## TECHNICAL MEMORANDUM

Re: **RI Phase 2 Modification No. 1  
Nevada Environmental Response Trust Site  
Henderson, Nevada  
Ramboll Environ Project No. 21-41400C, M03B**

**RI Phase 2 Modification No.1**  
 Nevada Environmental Response Trust Site  
 Henderson, Nevada

Figure 1 RI Phase 2 Modification No. 1

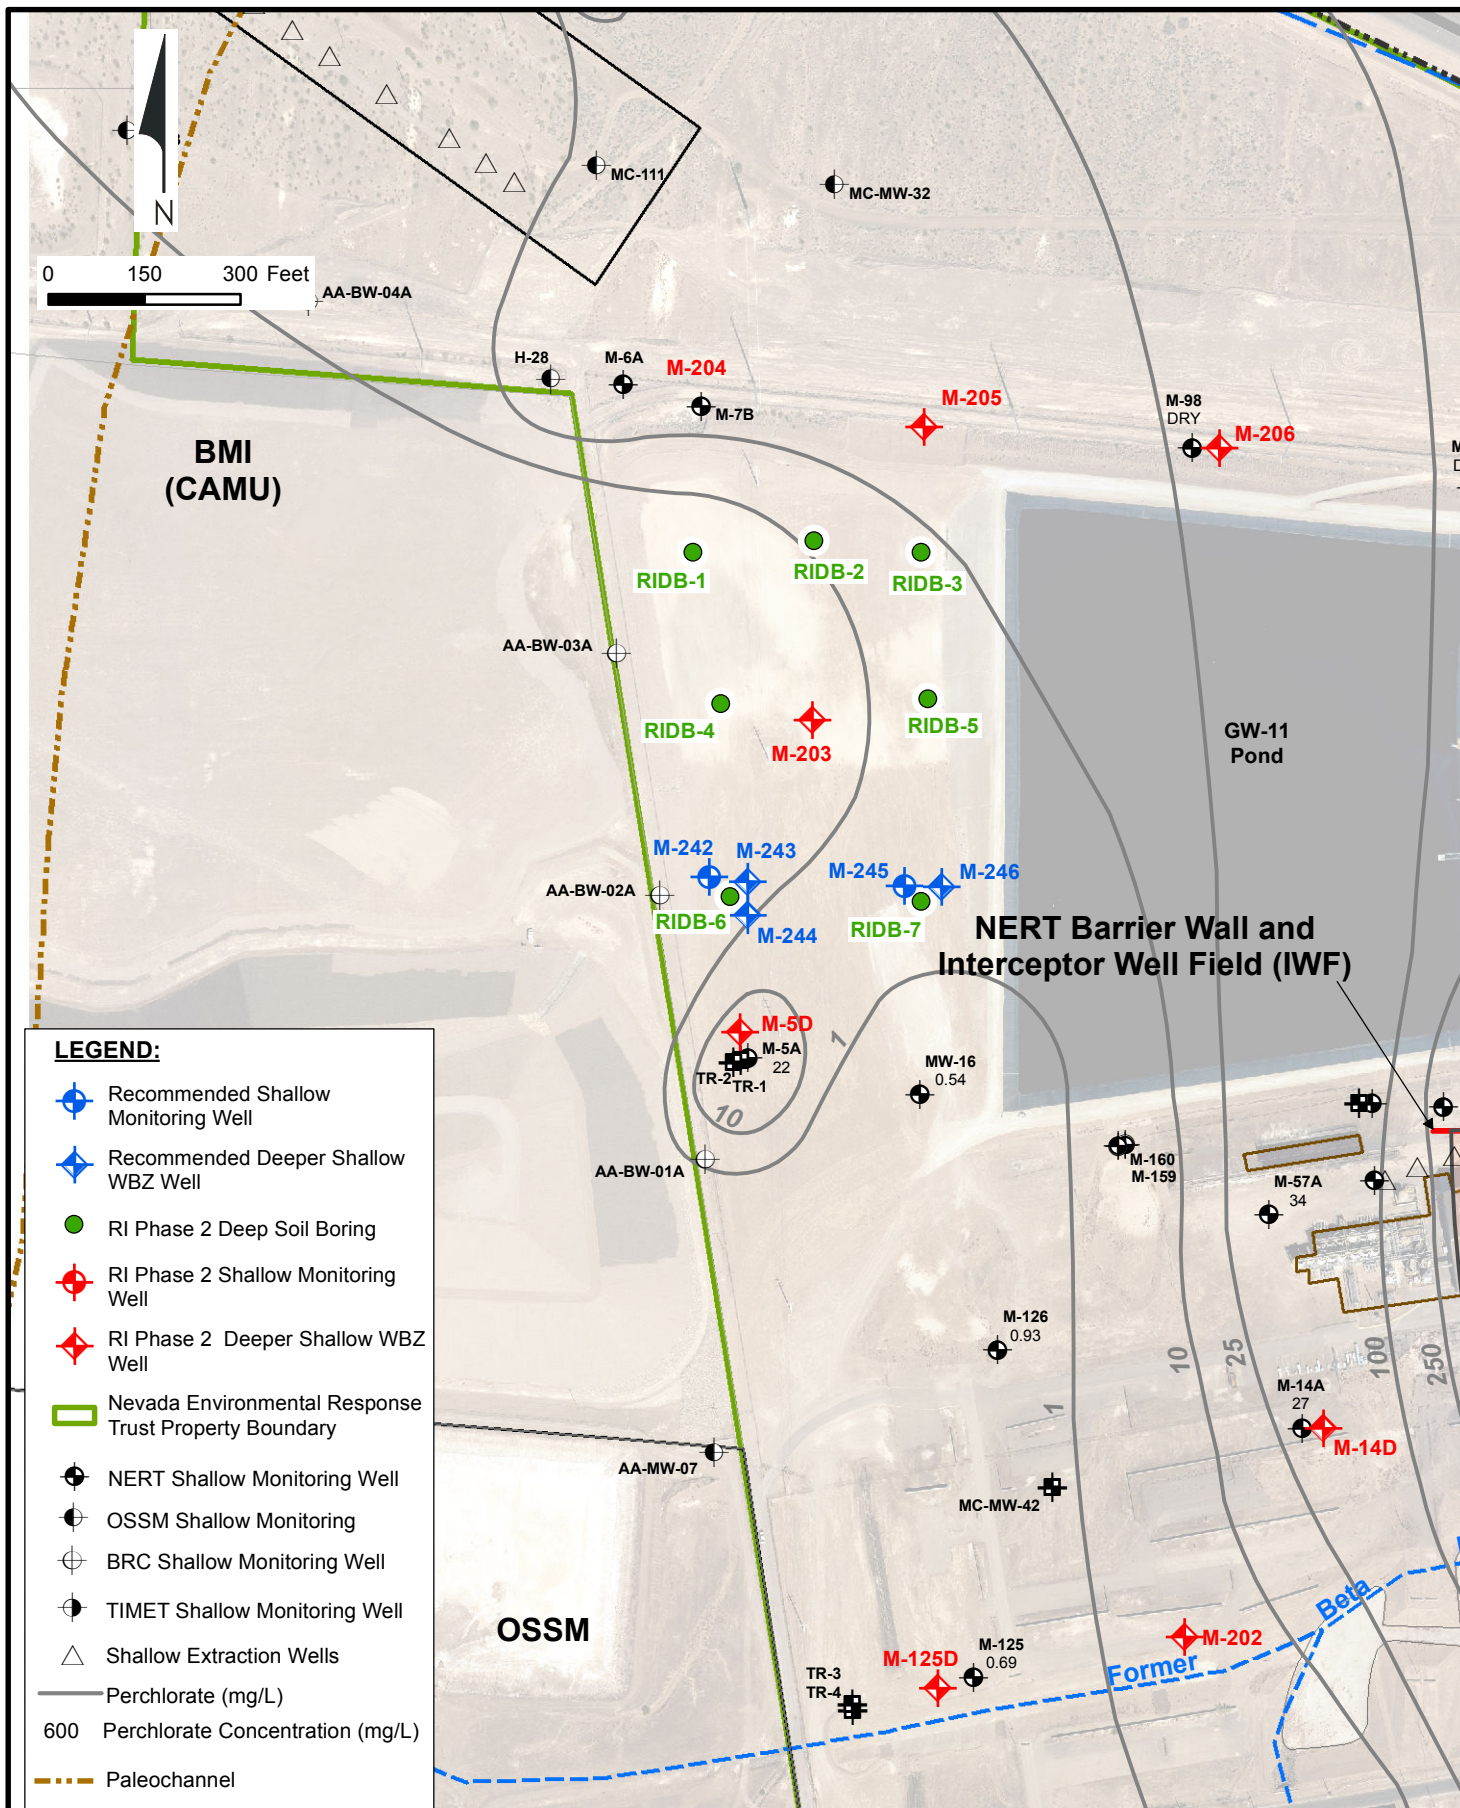
Three clustered groundwater monitoring wells are recommended adjacent to RIDB-6. Two wells (M-242 and M-243) will assess groundwater concentrations in depth intervals where VOCs have been found in saturated soil. Well M-242 will be screened from 38-53 ft bgs, and well M-243 will be screened from 60-70 ft bgs. Both wells will be screened in the UMCf. In order to further delineate the vertical extent of VOCs in the UMCf, a third deeper well (M-244) will also be installed at this location. The pilot boring for well M-244 will be drilled to a depth of 130 ft bgs, and PID readings will be recorded during drilling for screening purposes. Soil samples will be collected for chemical analysis from depths of 60, 70, 80, 90, 100, 110, 120, and 130 ft bgs. Similar to RIDB-6, the soil samples will be tested for perchlorate, chlorate, total chromium, nitrate, nitrite, VOCs, and moisture content. Well M-244 will be screened below 70 ft bgs in the depth interval where the highest PID readings are recorded, or from 80-90 ft bgs if PID readings decrease to 0 ppm below 70 feet.

Based on these findings, two clustered groundwater monitoring wells are recommended adjacent to RIDB-7. Well M-245 will be screened from 35-50 ft bgs, and well M-246 will be screened from 60-70 ft bgs. Both wells will be screened in the UMCf.
